UNITED STATES PATENT AND TRADEMARK OFFICE

APPLICATION NO.	FILING DATE	FIRST NAMED INVENTOR	ATTORNEY DOCKET NO.	CONFIRMATION NO.
10/781,175	02/18/2004	Michael R. Oldenburg	6919.03	1818
29293	7590	07/17/2006	EXAMINER	
FREUDENBERG-NOK GENERAL PARTNERSHIP LEGAL DEPARTMENT 47690 EAST ANCHOR COURT PLYMOUTH, MI 48170-2455				PATEL, VISHAL A
ART UNIT		PAPER NUMBER		
		3673

Office Action Summary	Application No.	Applicant(s)	
	10/781,175	OLDENBURG, MICHAEL R.	
Examiner	Art Unit		
Vishal Patel	3673

DETAILED ACTION

FIG. 1

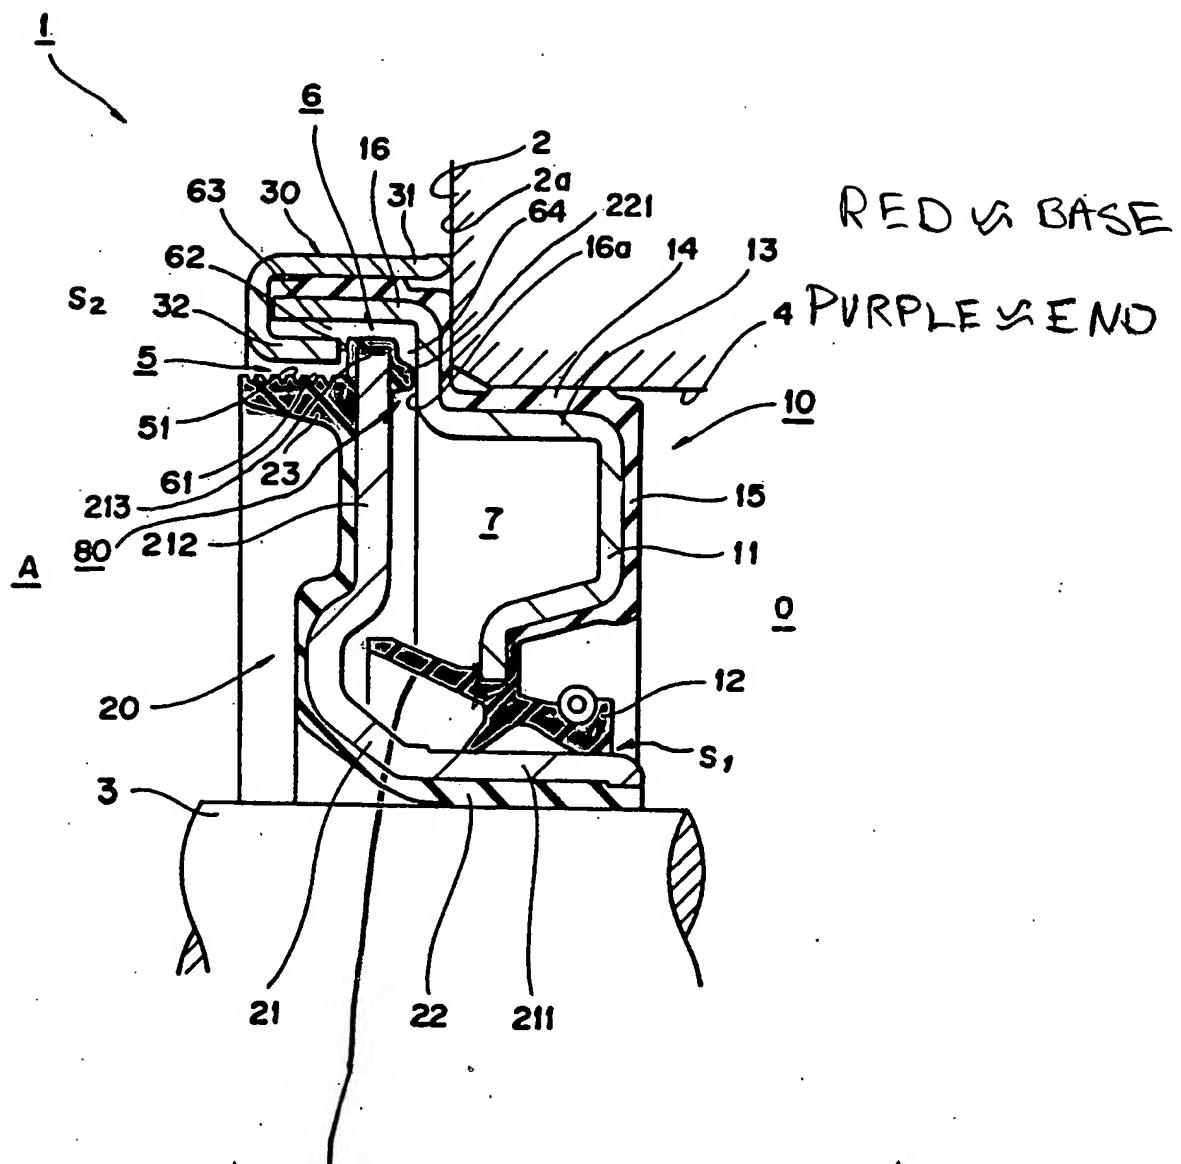
Regarding claim 1: Heinzen figure 1 (see attached figure 1), discloses a seal for sealing a shaft, the seal comprising a sleeve constructed to be disposed generally coaxially around the shaft (sleeve 211) and comprising a parallel sleeve portion (sleeve portion that contacts the shaft 3) that is generally parallel to the longitudinal axis of the shaft and a radially extending sleeve portion (portion having 212) that extends generally radially away from the longitudinal axis of the shaft, an outer housing (housing that surrounds the sleeve) configured to generally surround the sleeve and comprising a parallel housing portion (portion 16) that is generally parallel to the longitudinal axis of the shaft, a radially extending housing portion (below 11 that has a base of a protrusion) that extends generally radially towards the longitudinal axis of the shaft, and a faceplate portion (portion between 16 and 13 and having surface 16a) that extends generally radially towards the longitudinal axis of the shaft, a first elastomeric protrusion (221 that has acute angle on surfaces that face the shaft and housing portion 16) extending between the radially extending sleeve portion and the faceplate portion and including a base (base of 221 that is in red in the attached figure 1) and an end (end that are indicated in purple in the attached

figure) generally opposite the base (end of 221) and oriented radially towards the longitudinal axis of the shaft (the end extends radially towards the longitudinal axis of the shaft) and a second elastomeric protrusion (see attached figure) including a base secured to the housing and an end generally opposite the base, wherein the end is oriented radially away from the longitudinal axis of the shaft. All the protrusions that are on the radially extending housing portion have a base that is adjacent to a distal end of the radially extending housing portion (see attached figure).

As shown in the attached figure 1 by red and purple markings the base and end of protrusions, respectively.

Regarding claim 20: The seal having a third elastomeric protrusion (protrusion above the distal end of 212 or 23) including a base secured to the radially extending sleeve portion and an end generally opposite the base, wherein the end is oriented both radially away from the longitudinal axis of the shaft and axially outwardly (see attached figure).

2nd Protrusion that extends away from shaft axis.

FIG. 2

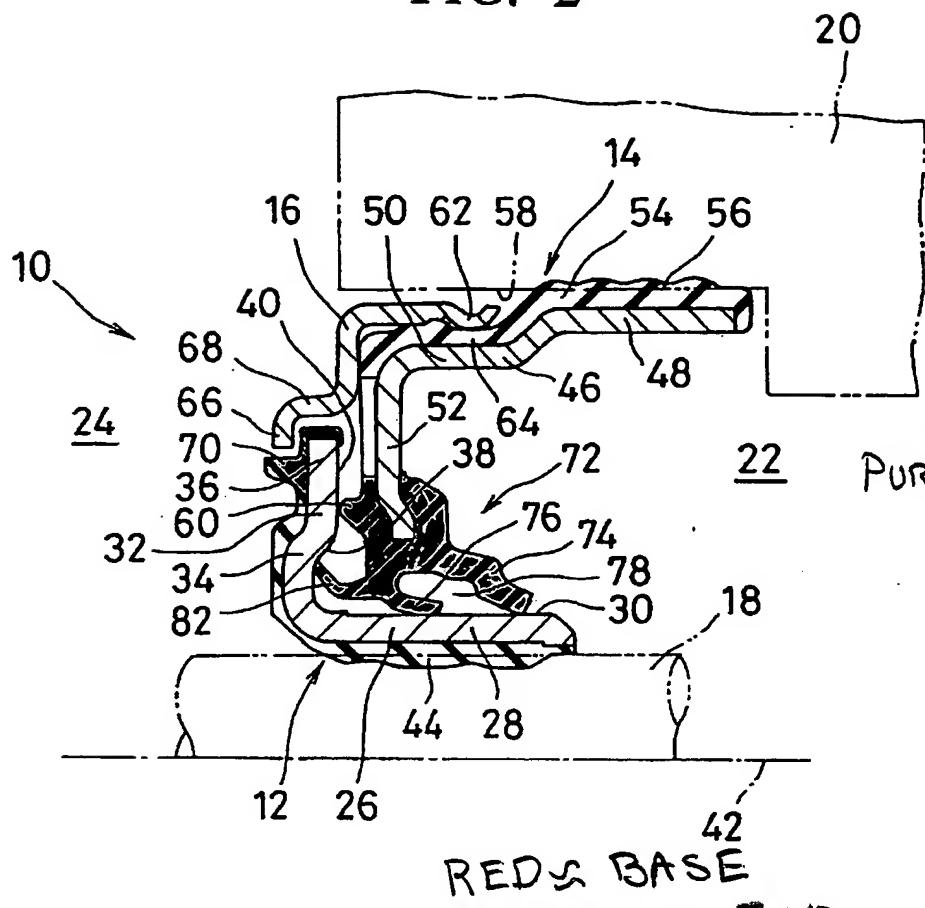
As shown in the attached figure 2 by red and purple markings, the first protrusion 70 has a base and an end, where the end is generally opposite the base, the end is oriented radially towards the longitudinal axis of the shaft and between the radially extending sleeve and the faceplate portion.

Applicants' argument against Ganda that the first protrusion is between the sleeve and the face plate is not persuasive because as shown in the attached figures the protrusion is between the face plate and the radial portion of the sleeve. Furthermore as shown in the figures the first protrusion is extending toward the longitudinal axis of the shaft (see attached figures).

RED \approx ^{1st} Protrusion
Base

PURPLE \Leftarrow 1st Protrusion
End that
Extends Towards
The Longitudinal
Axis of the
Shaft.
